Comments of the Natural Resources Defense Council (NRDC) on the History of Energy Efficiency in the 2011 IEPR – Electricity, Natural Gas, and Transportation Energy Preliminary Forecast

Docket Numbers 11-IEP-1C, 11-IEP-1K, 11-IEP-1L

May 25, 2011

Figure 1: Original Graph of Energy Efficiency Savings
(Published in 2005 in Energy Action Plan)¹¹

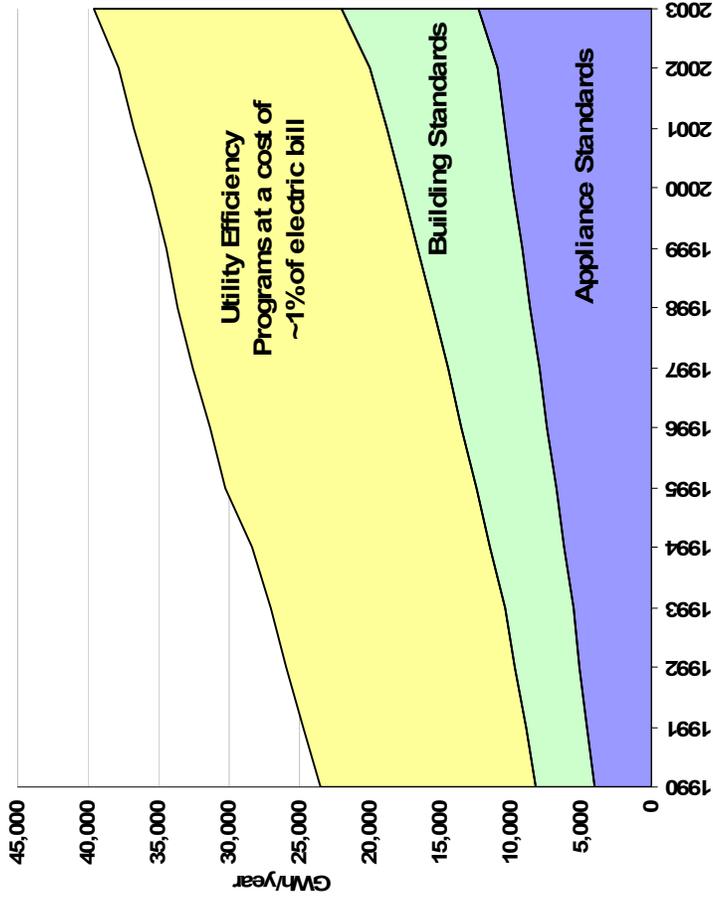
It is immediately apparent comparing these two graphs that the CEC's 2009 graph drastically reduced the savings attributed to utility energy efficiency programs *by over 75%*.¹³ In some historical years, the savings attributed to efficiency programs were reduced by 92% (i.e., the CEC only used 8% of the savings that were reported in those years).¹⁴ As discussed above, these revised estimates vary sharply from the CPUC's official record of energy savings during those years. The CEC's extreme reductions were made without a full public process and in the absence of any further evaluation studies by or on behalf of the CEC. Further, the basis for most of the reductions is simply the "judgment" of CEC staff. Although professional judgment is often necessary and valuable in the CEC's work, it should not replace well-documented information that has already been formally adopted by an agency following a thorough public process.

Figure 2: Revised Graph of Energy Efficiency Savings,
(Published in 2009 California Energy Demand)¹²

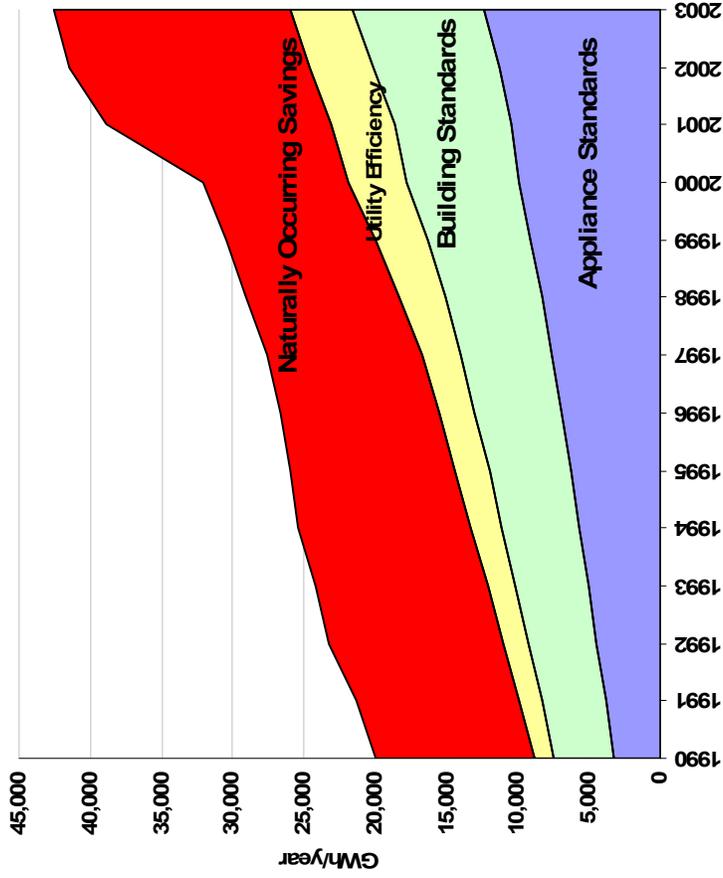
1. NRDC strongly recommends that the 2011 IEPR retract the inaccurate 2009 IEPR graph, which misrepresents the sources of historical energy savings and revises prior energy saving data without sufficient basis.

For the 2011 demand forecast, the Commission should adopt a simple graph depicting the state's total energy efficiency savings. We strongly urge the CEC to use only the total amount of energy efficiency savings, which is the necessary information for a demand forecast, and not claim to determine causes of savings until a further process is developed to specifically address the historical attribution of California energy savings. The present demand forecast model was not intended to determine the various causes of total savings and should not be presented as such. Instead, the demand forecast model was intended to predict future demand as accurately as possible. Given this objective, savings can either be embedded inside the forecast, or incremental to the forecast, so long as future demand is accurately predicted. However, all the savings embedded within the forecast do not get represented in the 2009 graph, only the incremental impacts.⁶ Thus, the demand forecast does not intend to depict total savings. Further, the amount of savings attributed to various causes changes depending on the order in which the model is run. Thus, the demand forecast does not intend to determine various causes nor the total amount of savings.⁷

Figure 4: Graph of Energy Efficiency Savings,
(Published in NPCC's 2010 6th Power Plan)¹⁸

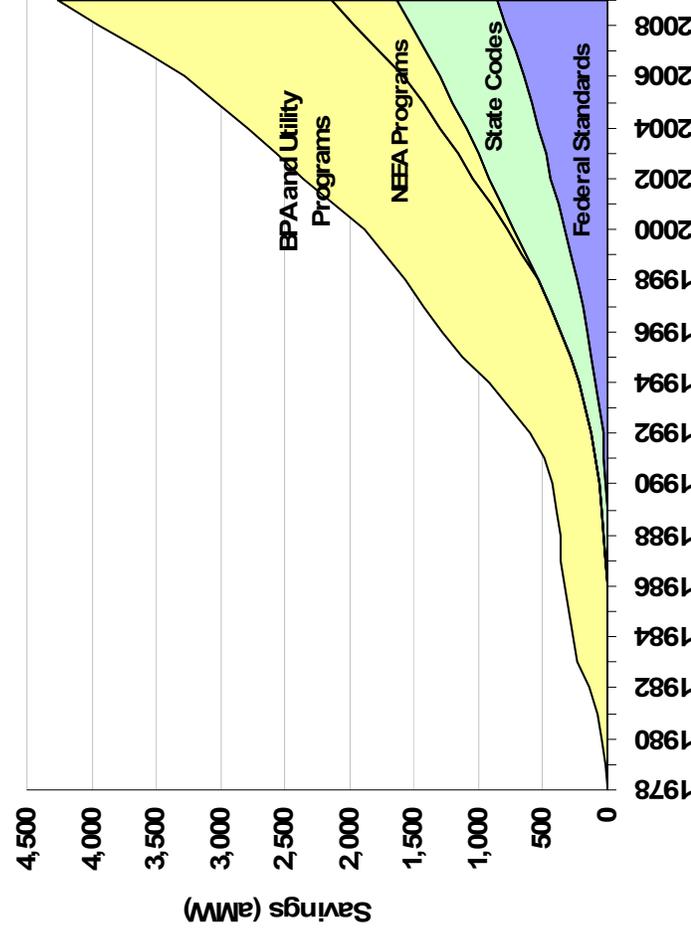
The NPCC estimates about half of the energy savings are attributed to utility programs, similar to the CEC's original graph from 2005. However, the CEC's 2009 graph uses drastically lower values, as described above, which are incommensurate with how our neighboring region estimates efficiency. We recommend that the CEC consult with the NPCC to compare methodologies and assumptions to discuss possible improvements to how California accounts for the impacts of efficiency program.
